INITIAL FIRE SAFETY INSPECTION REPORT

International Trading Services Ltd (Extension)

RSC ID: 25611

Date: 18-Mar-2024

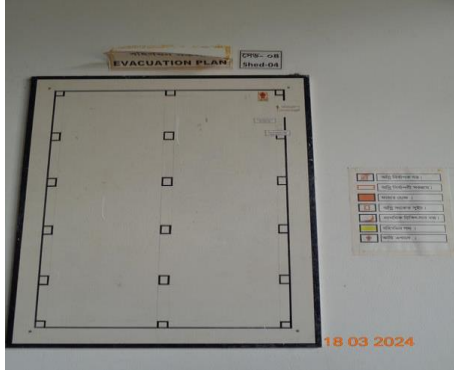
F-2	Fire Rated Construction	Catwalk has been constructed on High rack storage and the area of the intermediate deck creates a full floor where the size of the deck is more than 33% of the total floor area so as requires fire rated separation. Location: Shed-2,3 and 6.	Maintain fire separation (3hr for type 1) between floor to floor as per BNBC 2006 Table 3.3.1. Provide required fire rating on the structural elements by following Table-3.2.4, 3.1.9 & Table 4.4.1 of the RSC Technical Guidelines Standard or Table 3.3.1 of BNBC-2006. Consult a qualified fire protection engineer to design the rated construction barriers in between two floors and in structural members. Factory shall submit all required product datasheet, installation design along with design philosophy to RSC for review prior to installation on site.	Within 3 months

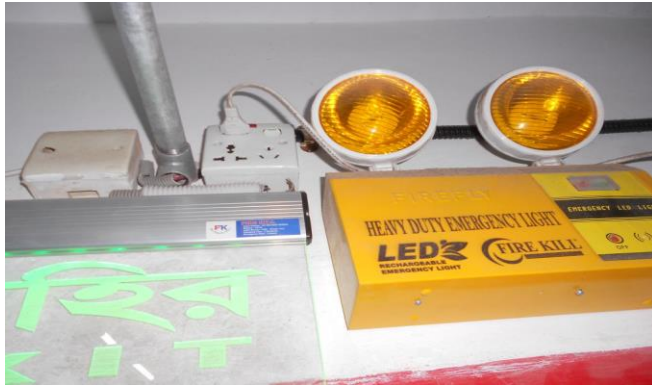
F-7	Means of Egress	Sliding doors are provided at building exits. Location: Finishing Shed	Replace all collapsible gates/ sliding doors/ rolling shutter doors along the means of egress with side-hinged, swinging egress doors. If locks are required for security reasons, utilize specialized door locking features complying with NFPA101.	Within 1 month
